PRAIRIE ISLAND NUCLEAR GENERATING PLANT

REQUEST FOR AMENDMENT TO  
OPERATING LICENSE NOS. DPR-42 & DPR-60

(License Amendment Request Dated July 11, 1984)

Evaluation of Proposed Changes to the Technical Specifications  
Appendix A of Operating Licenses DPR-42 and 60

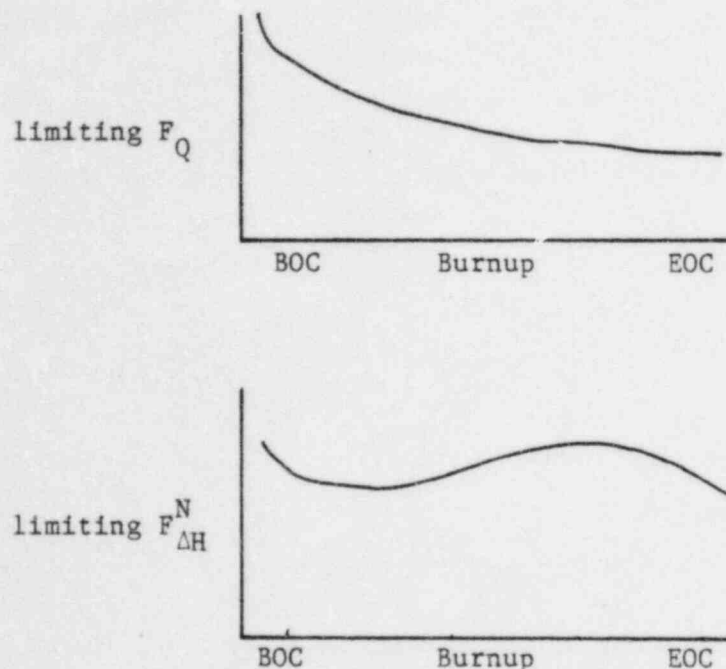
As shown on the above curve  $F_Q$  typically peaks sharply at the beginning of the cycle and generally decreases throughout the cycle.  $F_{\Delta H}^N$  will generally increase as Gadolinia burns out in mid-cycle. Therefore,  $F_Q$  can be limiting at the beginning of cycle but  $F_{\Delta H}^N$  can limit mid-cycle operations. The requested changes will allow flexibility by allowing, for example, a higher  $F_Q$  limit at beginning of cycle and a higher  $F_{\Delta H}^N$  limit in mid-cycle.
